TRANS/WP.29/GRSP/34
18 February 2004

World Forum for Harmonization of Vehicle Regulations (WP.29)

Working Party on Passive Safety (GRSP)

REPORT OF THE WORKING PARTY ON PASSIVE SAFETY (GRSP)
ON ITS THIRTY-FOURTH SESSION

Annex 5, insert a new figure 1a, to read:
"

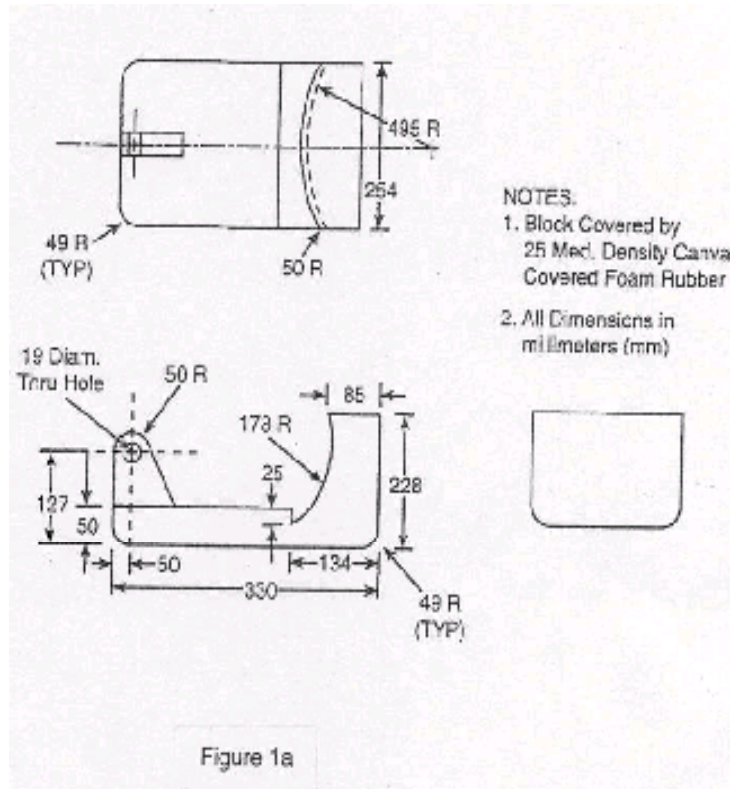
"6.3.4. Traction devices to be used in the tests described in paragraph 6.4. below are shown in annex 5. The devices shown in annex 5, figure 1 are placed onto the seat cushion and then, when possible, pushed back into the seat back while the belt strap is pulled tight around it. The device shown in annex 5 figure 2 is placed in position, the belt strap is fitted over the device and pulled tight. No preload shall be introduced to seat belt anchorages during this operation.

The traction device of either 244 mm or 406 mm used at each seating position shall be such that its width is as close as possible to the distance between the lower anchorages.

The positioning of the traction device shall avoid any mutual influences during the pull test which adversely affects the load and load distribution."

Figure 2, amend to read:

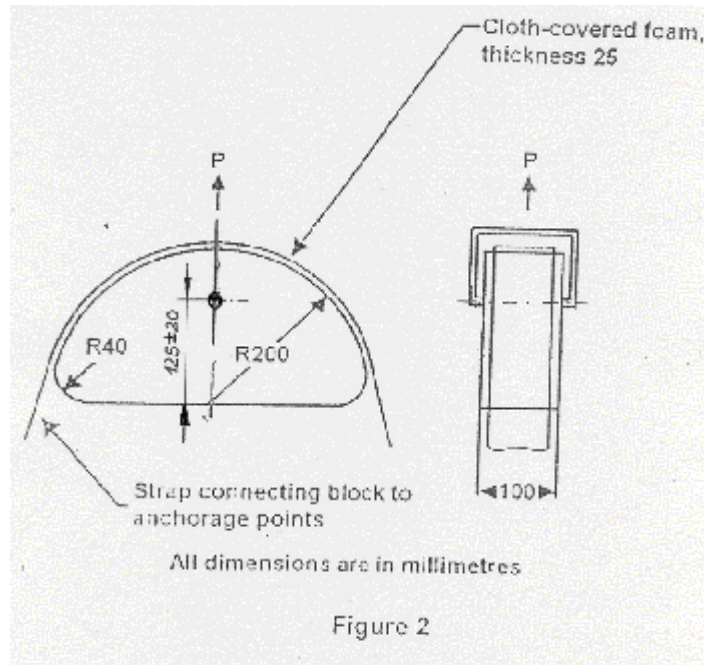
For the fixing of the strap the shoulder belt traction device may be modified by adding of two land edges and /or some bolts to avoid any drop off of the strap during the pull test."
